Attachment "C"

Request for Waivers and Response to Comments

Re: Aloft Hotel Requested Development Review Board (DRB) Modifications

Re: Aloft Hotel

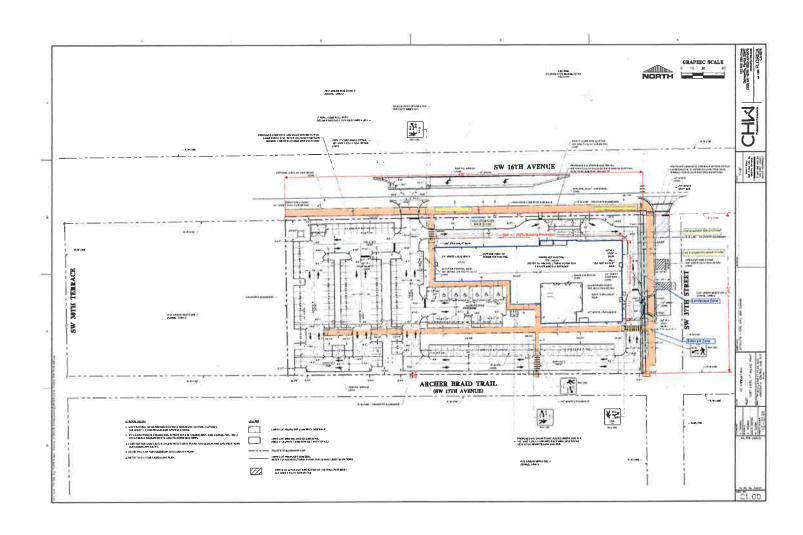
6. Allow a reduced number of Bicycle Parking

<u>Justification:</u> The applicant is requesting a 50% reduction in bicycle parking for the requested hotel use. The reason for this request is due to several factors. Historically and by trend, very little patron traffic occurs at hotels by bicycle. Shuttles, taxis, uber, and personal vehicles are the predominant method of arrival and departure. The required 40 spaces represent ¼ of the entire hotel. Reduction to 20 spaces will provide adequate parking for the likely rider, which would be staff, administration, or students accessing the hotel to meet parents or friends. Further, the proximity to the Archer Braid Trail introduces numerous other bicycle parking locations within very close proximity.
